ARKANSAS NUCLEAR ONE - UNIT 1

IMPROVED TECHNICAL SPECIFICATIONS SUBMITTAL

VOLUME 2 OF 7

January 28, 2000

3.5.2.5 Control rod positions:

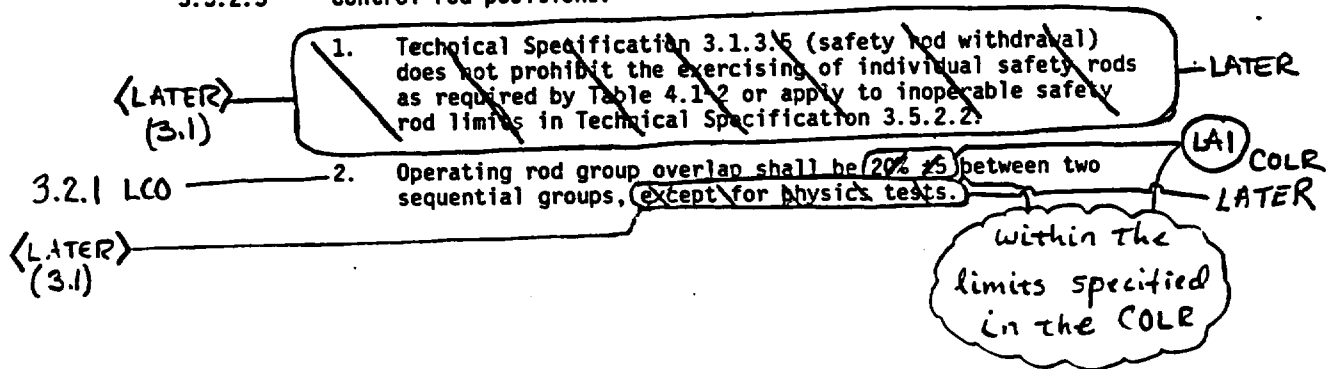
- < Add SR 3.2.1.1 > — (M5)
- < Add SR 3.2.1.2 > — (M5)
- < Add 3.2.1 RA A.1 with Note > — (M10)

- <Add 3.2.2 RA A.1 and Note> (M11) 3.2.1
- <Add 3.2.2 Condition B> (M2) 3.2.2
- <Add SR 3.2.2.1> (M5) 3.2.3
- <Add 3.2.3 RA A.1> (M12)
- 3.2.1 LCO Note (LATER) (3.1) <Add 3.2.1 RA E.1> (M7)

Figure B 3.2.3-1 (page 1 of 1)
Minimum Incore System for AXIAL POWER IMBALANCE Measurement

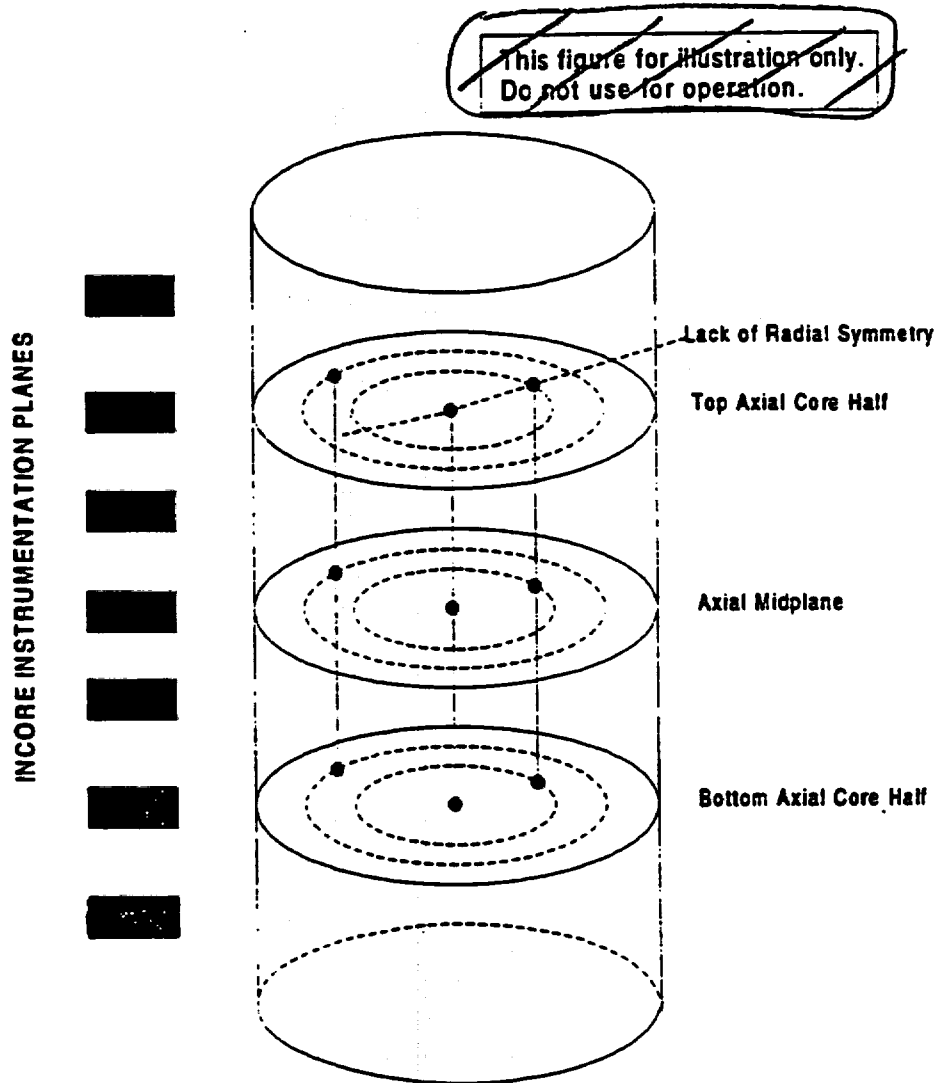
~~This figure for illustration only.
Do not use for operation.~~

edit

Figure B 3.2.4-1 (page 1 of 1)
Minimum Incore System for QUADRANT POWER TILT Measurement

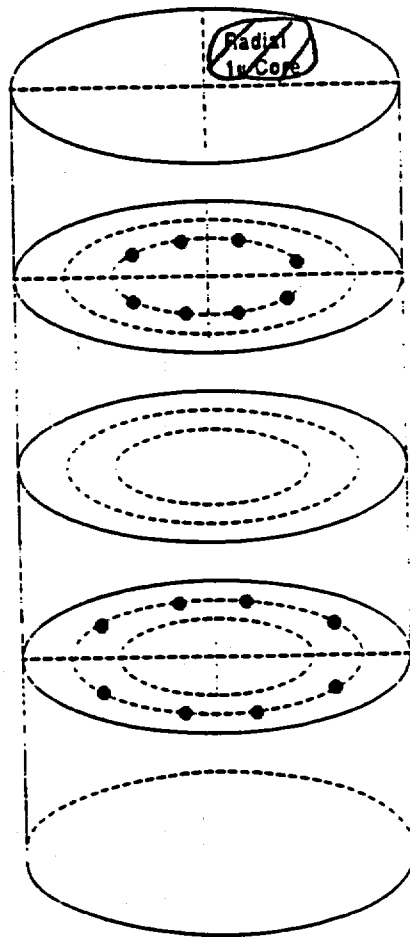
edit
